## Proposal for Supplement 3 to the 04 Series of Amendments to UN Regulation No. 95 (Lateral impact) \*,\*\*

### Submitted by the expert from France

### "Annex 5 – Appendix 2

#### FORCE-DEFLECTION CURVES FOR DYNAMIC TESTS

Figure 2a

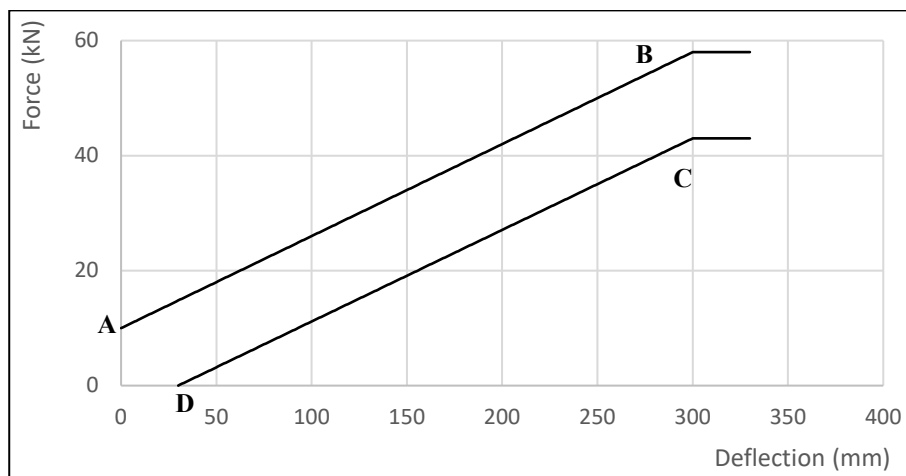
The text reproduced below was prepared by the expert from France to clarify the figures of Annex 5 – Appendix 2 and reintroduce legends which had been removed in serie 2 of amendments of this regulation. The modifications to the current text of the UN Regulation are marked in bold for new characters.

Deflection	Force
A	0 mm	10 kN
B	300 mm	58 kN
C	300 mm	43 kN
D	30 mm	0 kN

Figure 2a  
Blocks 1 & 3

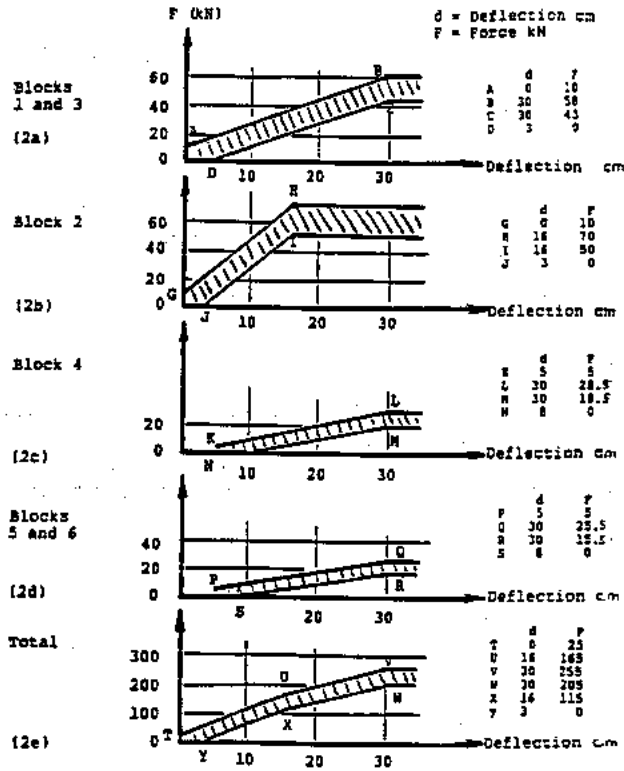
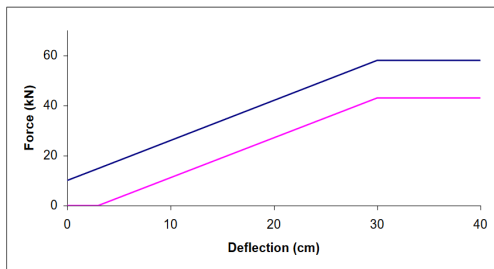
- This proposal aims at clarifying the force-deflection curves of Annex 5 – Appendix 2. The force-deflection corridors characterising the rigidity of the impactor were described in the original series of the UN Regulation No. 95 with a legend precisising the value of the characteristics points of the curves (A to Y).

In the serie 2 of amendments, the figures were updated (without changing the corridors) and the legend were removed.

This proposal aims at reintroducing the letters and the value in the legend for more clarity. The units of the deflection were also modified from cm to mm to be aligned with the units used in the rest of the text.
